ADDENDUM #2

Date:	25 March 2008	
To:	General Contractors	
From:	Bill Bowen, Project Manager, DFCM	
Reference:	Weber State University Hurst Center for Lifelong Learning	
DFCM Project #:	07110810	
Subject:	**Addendum No. 2**	
Pages:	Addendum	1 page
	Substitution Request	16 pages
	Architectural Addendum	38 pages
	Total Pages	**55 pages**

SK-1

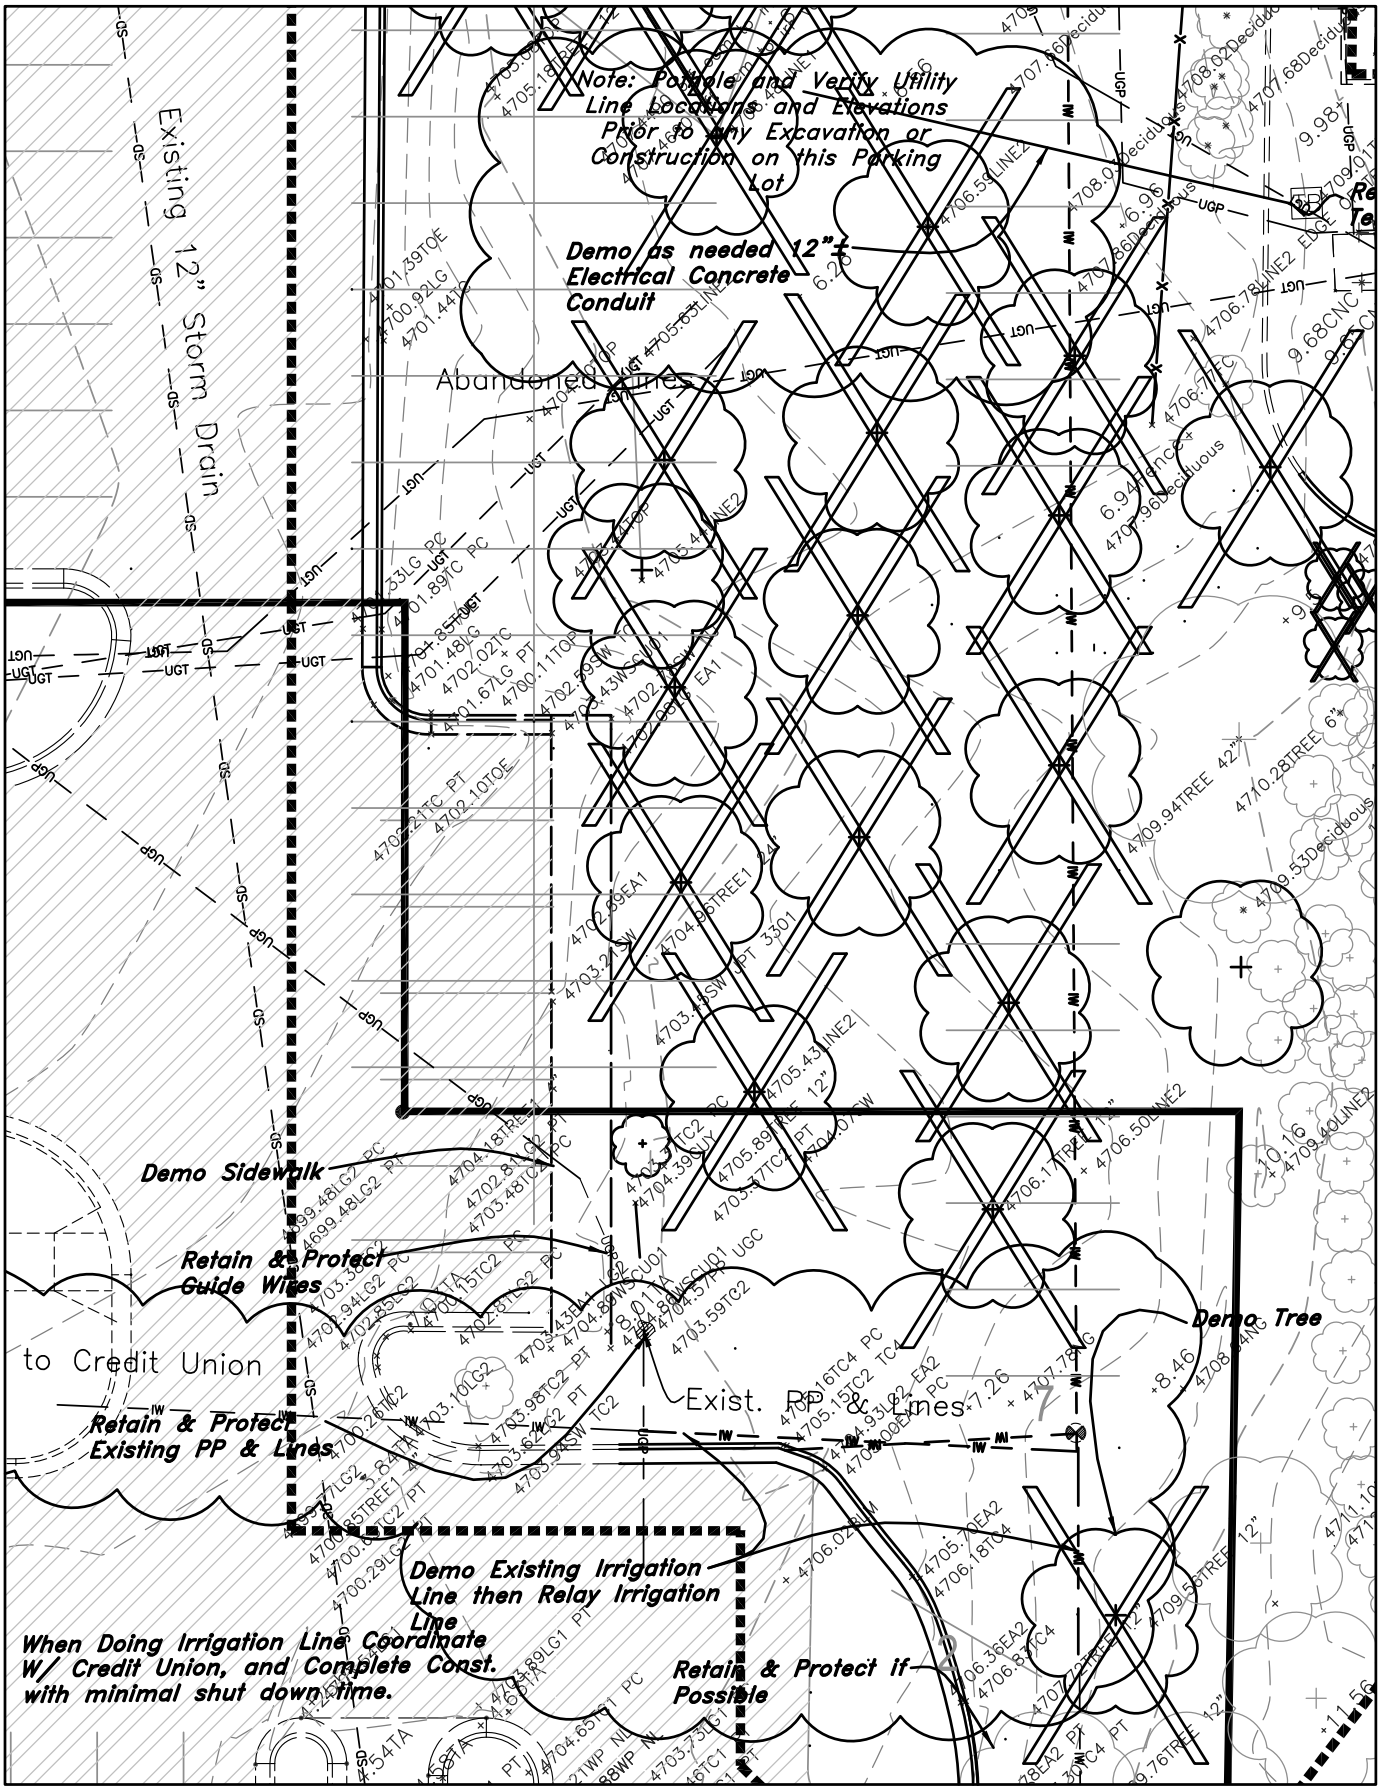
A2.24 Sheet CD002: showed a 12" more or less concrete conduit and several irrigation lines for demolition per attached SK-1 and SK-2.

Sheet Reference
SK-3

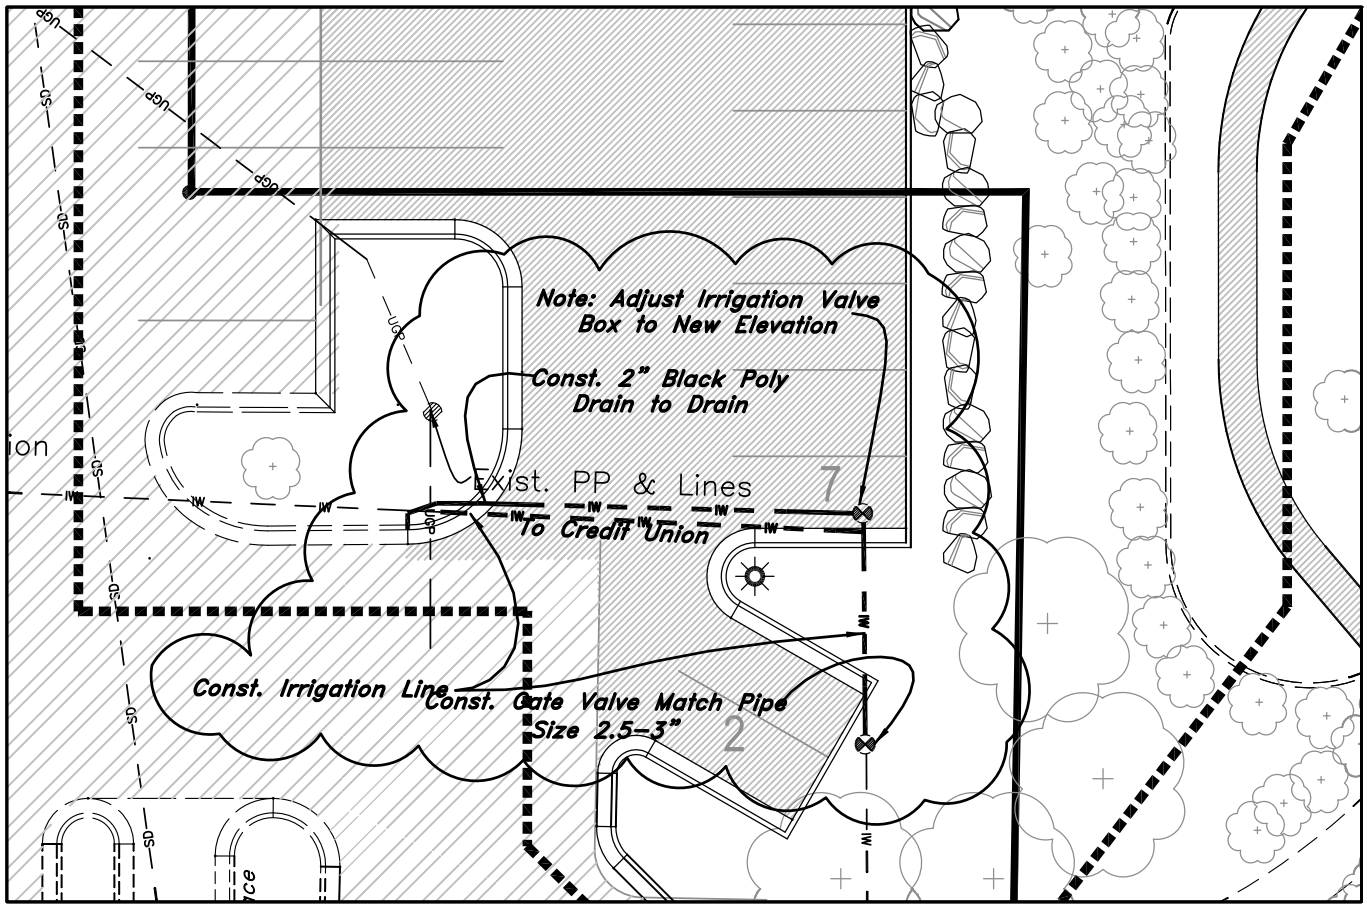
A2.25 Sheet CU301: Showed a new valve on an irrigation line, adjust grade for an irrigation line, reworked irrigation line and drain line, per attached SK-3.

SF101

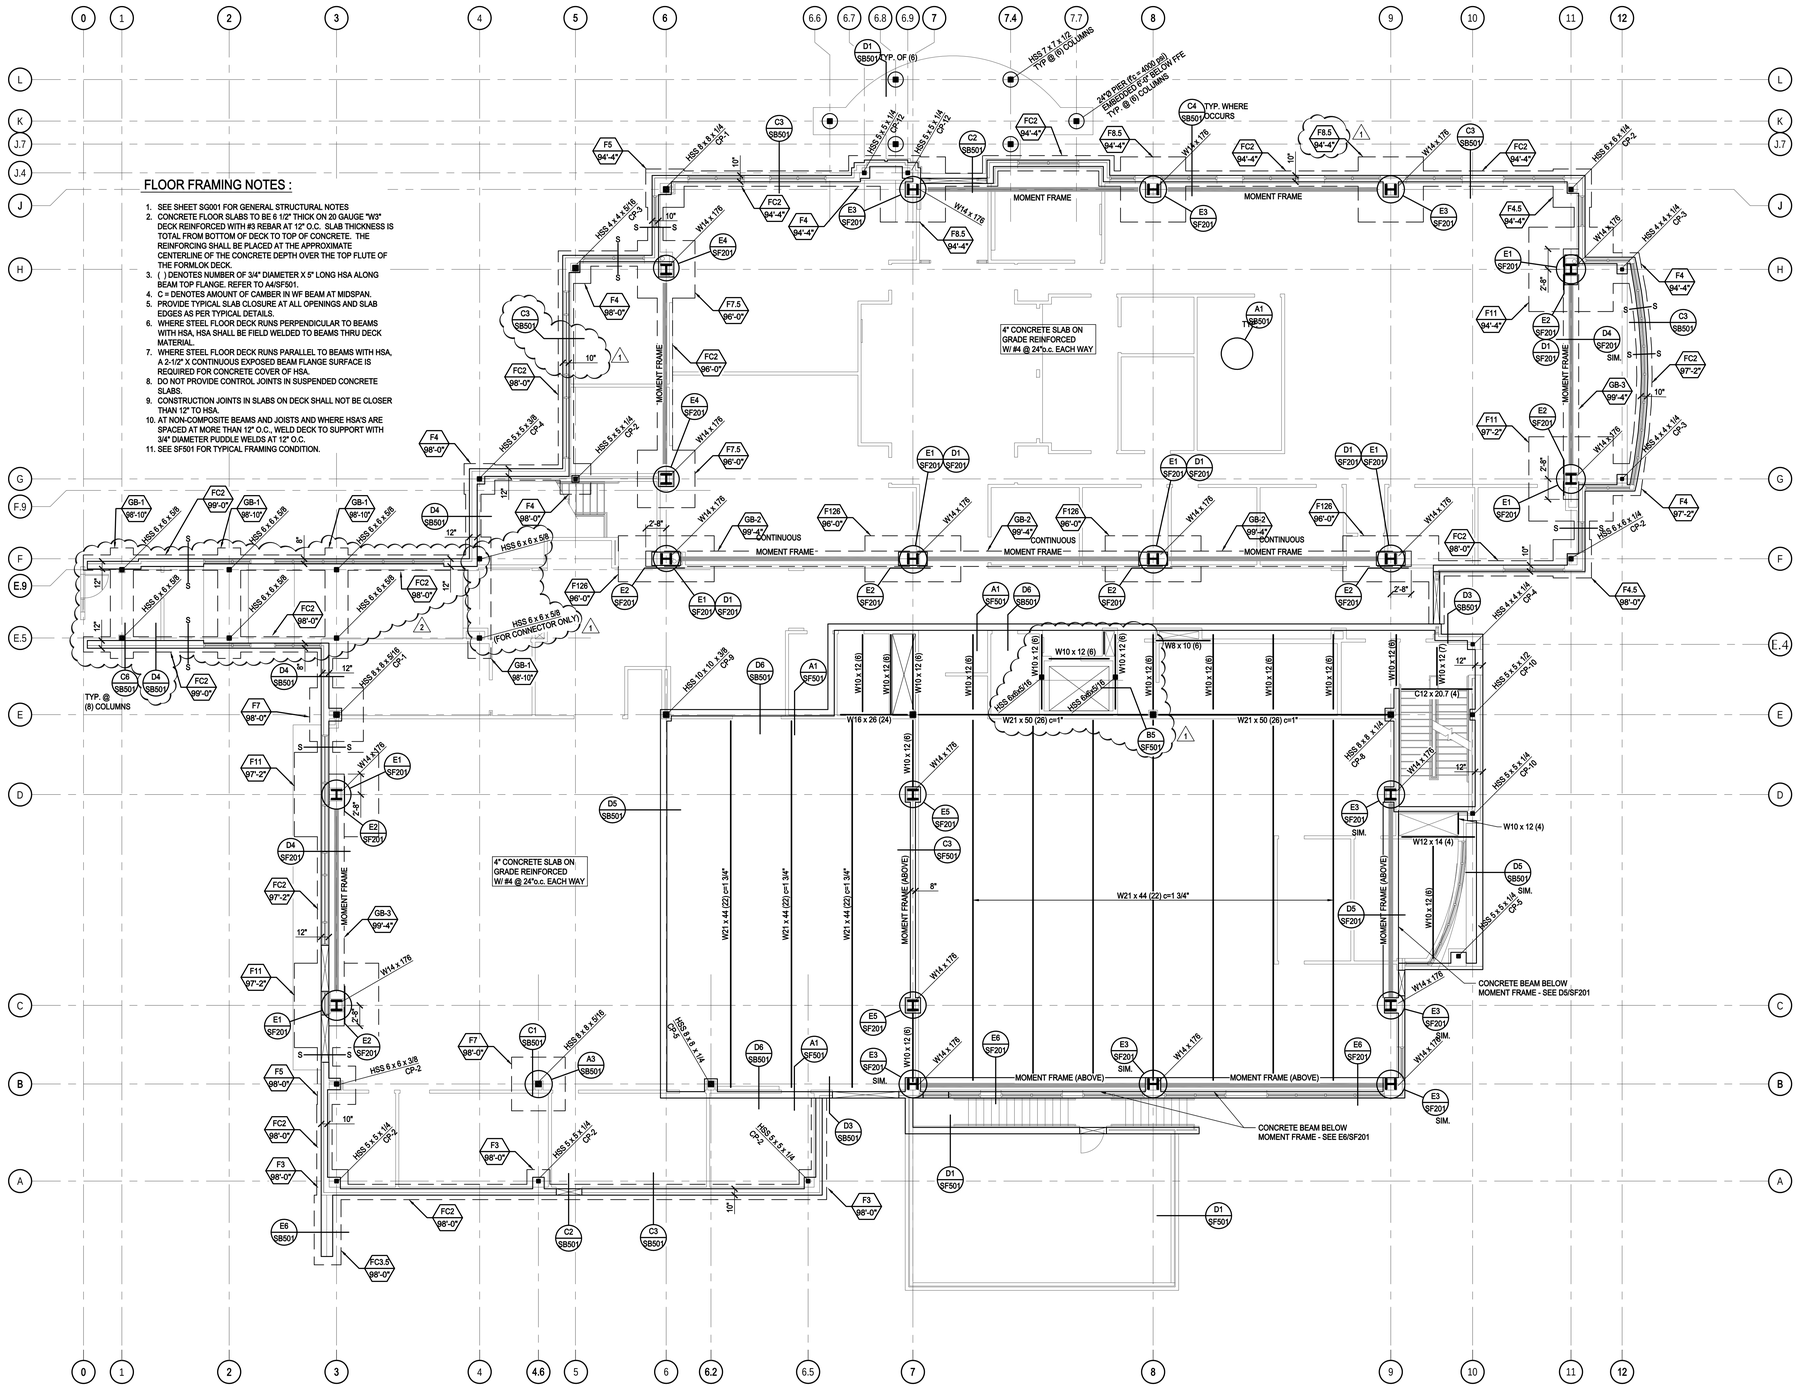
A2.28 Sheet SF101-
- The foundation walls have been revised at the Hurst Center/Alumni Center Connector between grids 0 and 3.

AE101

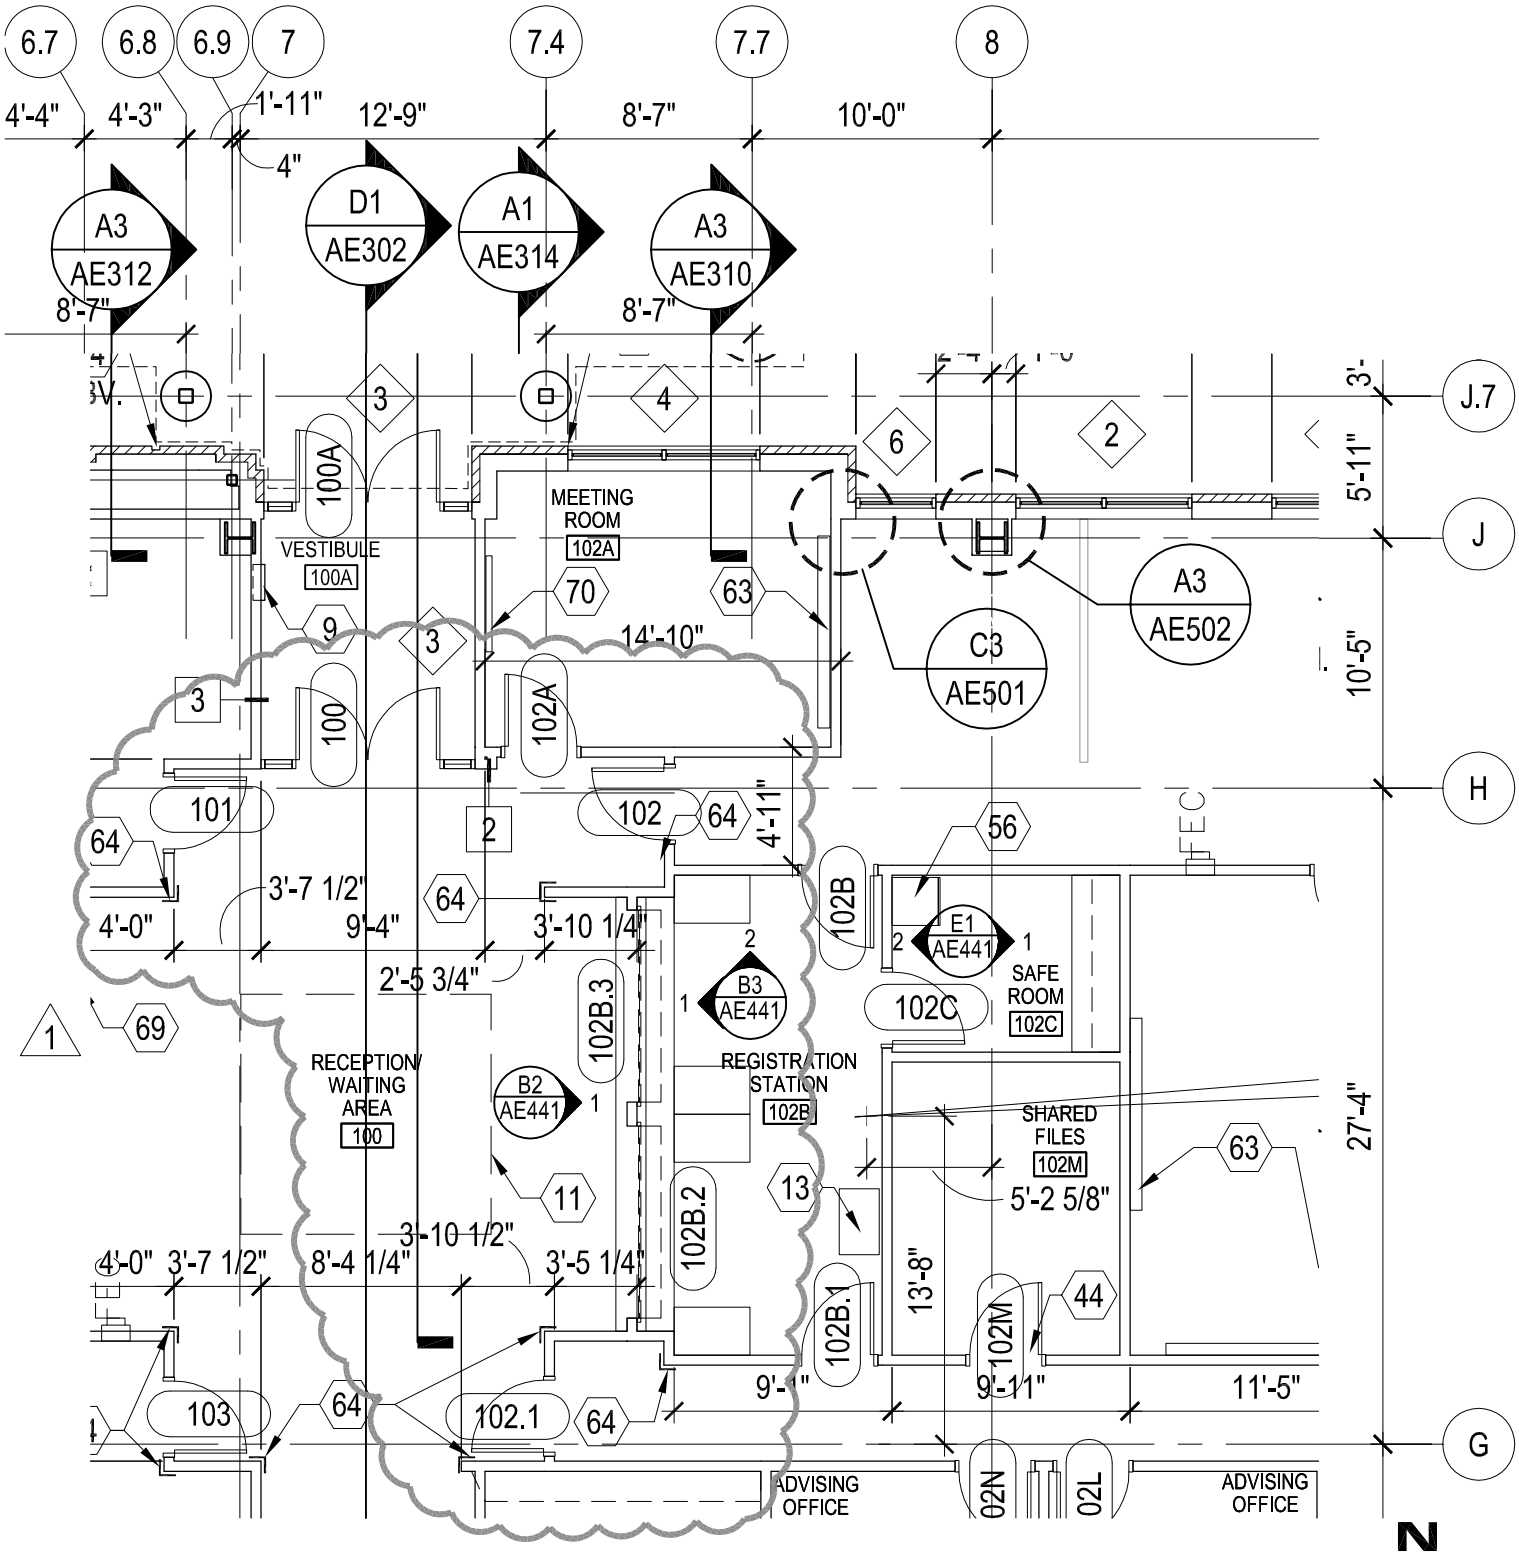
- Refer to sketch AD02-A01 for revisions to door locations 102 and 102A.
- Door 115.4 has been changed to a 6'-0" wide opening; revise masonry opening dimension on plans to 6'-8".

LEVEL ONE REFLECTED CEILING PLAN

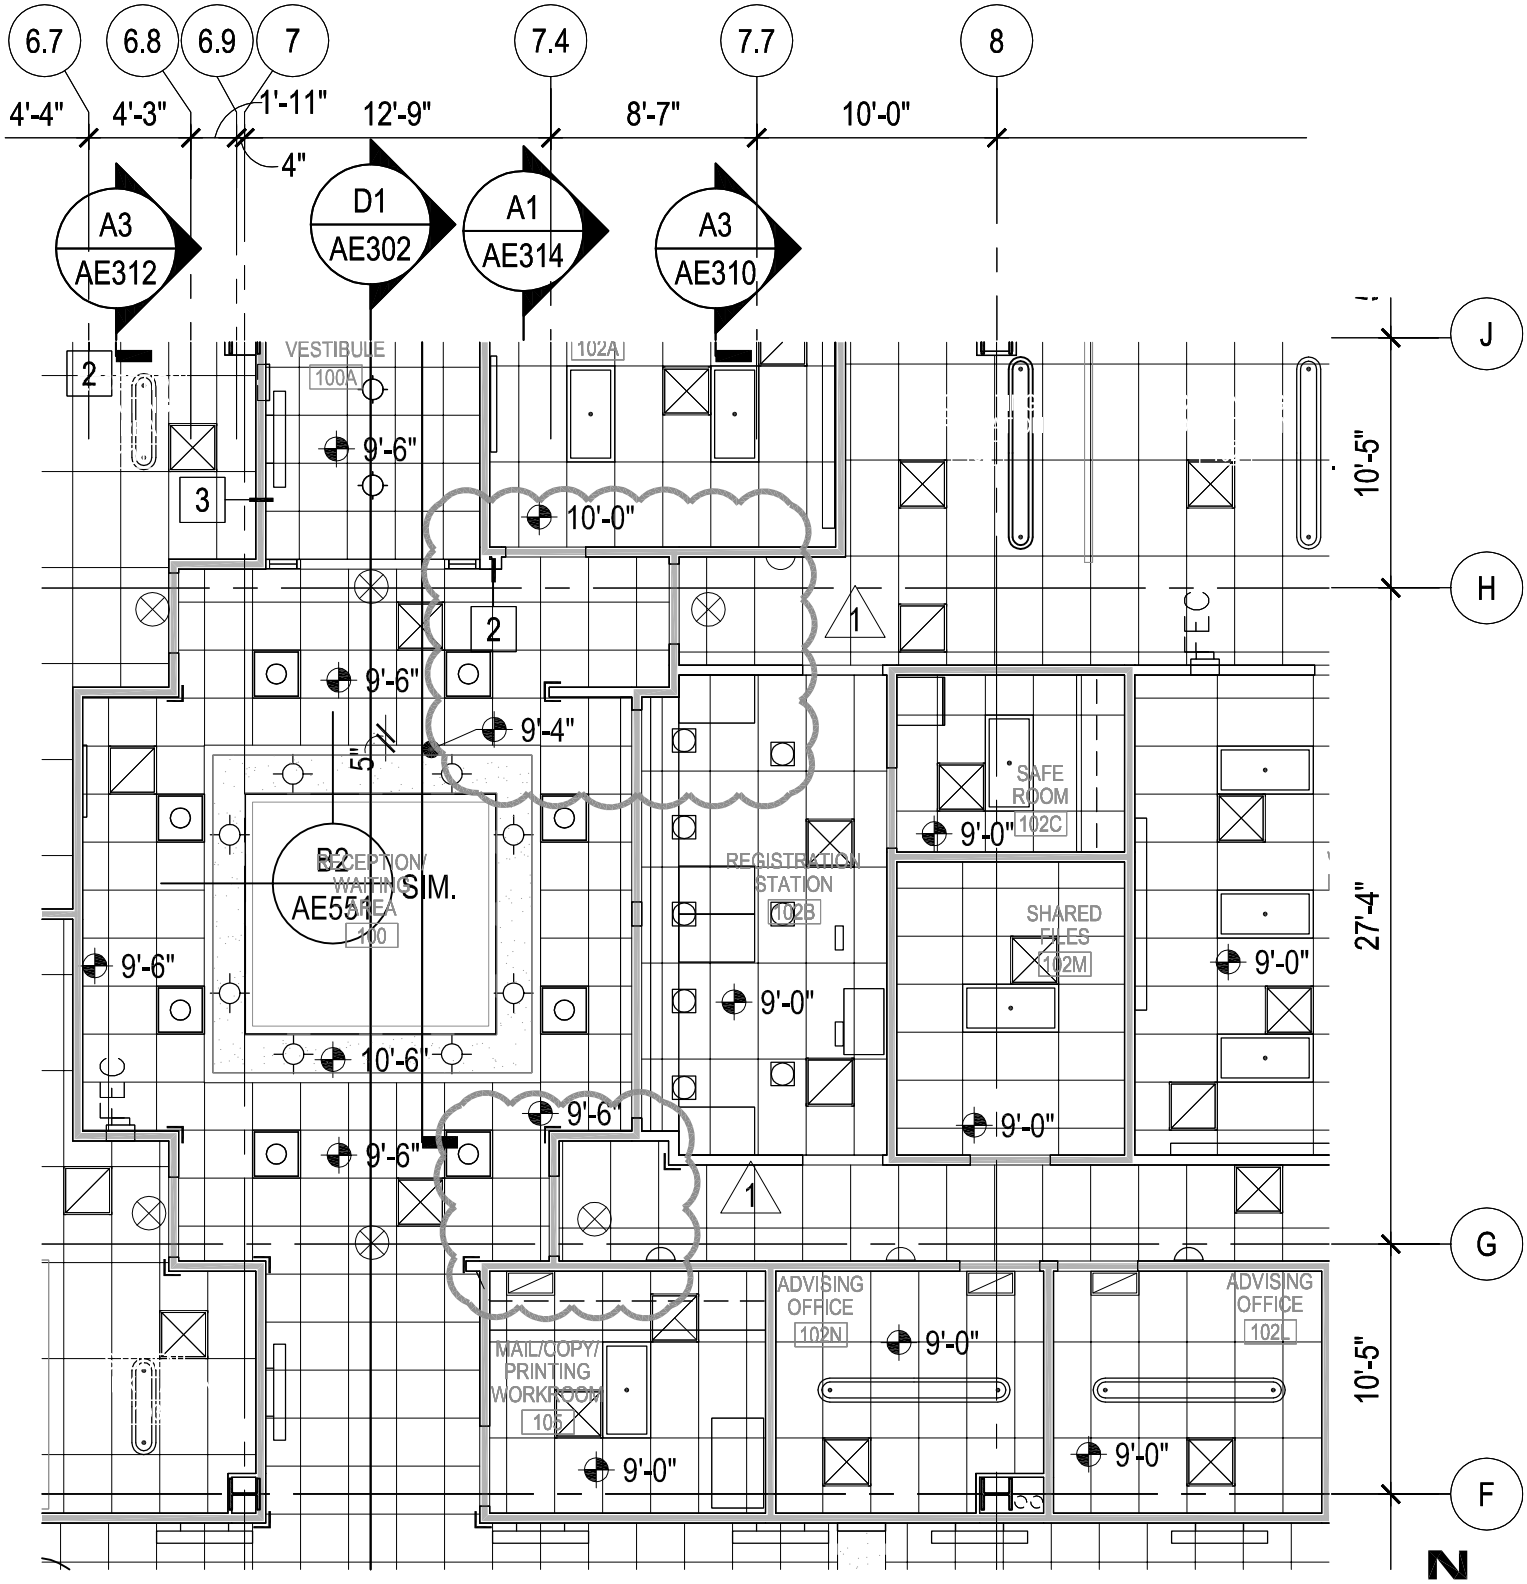
- Refer to sketch AD02-A02 for revisions to ceilings at doors 102 and 102A.
- Add a stepped soffit (similar to detail B5/AE551) to elevation 9'-4"along the west wall of Assembly #115, to align with the east faces of the column enclosures, to enclose a roof drain pipe. Frame the soffit to allow full depth for the pipe to slope to the north.
- Add a dropped soffit (detail B5/AE551) to elevation 8'-2" at the north wall of Men's Toilet Room #117 above the lavatories to conceal duct work.
-
